CIRCULATE TO:-		[REDACTED]		
SERVICE MGR.	X			
RECEPTION	X			
WORKSHOP	X			
PARTS	X	SUBJECT		30/10/96
		Front Axle Driveshaft - Oil Leak		NRR/54/03/96/EN
MODEL		AFFECTED VEHICLES		
New Range Rover		LP	348603 Onwards	
		LH		
		LJ		
		LD

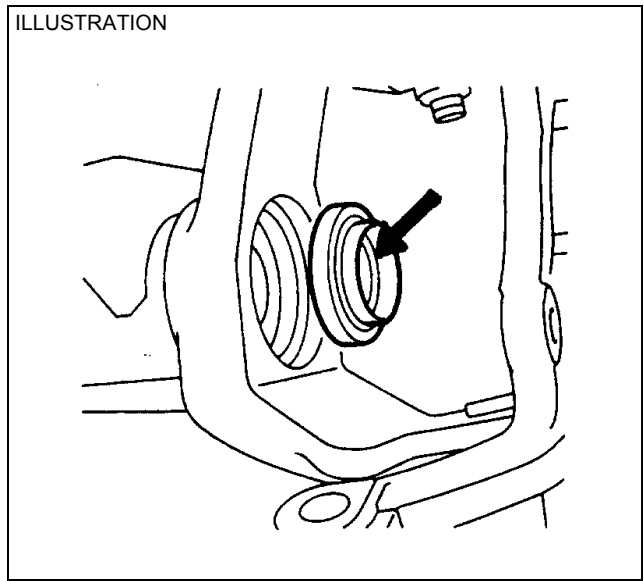
In the event of an oil leak becoming evident from the front driveshaft seal around the yolk area, a new driveshaft seal has been introduced.

Upon customer complaint of an oil leak around the driveshaft area, the new revised seal should be fitted, together with the brake caliper bolts and hub assembly bolts as detailed in the parts section.

FTC 4822 replaces FTC 3452 driveshaft seal

FTC 2996 brake caliper bolts (4 off)
 FC 112127P hub assembly bolts (8 off)

Note: New service tool No LRT-54-012 should be used in conjunction with the driveshaft seal.
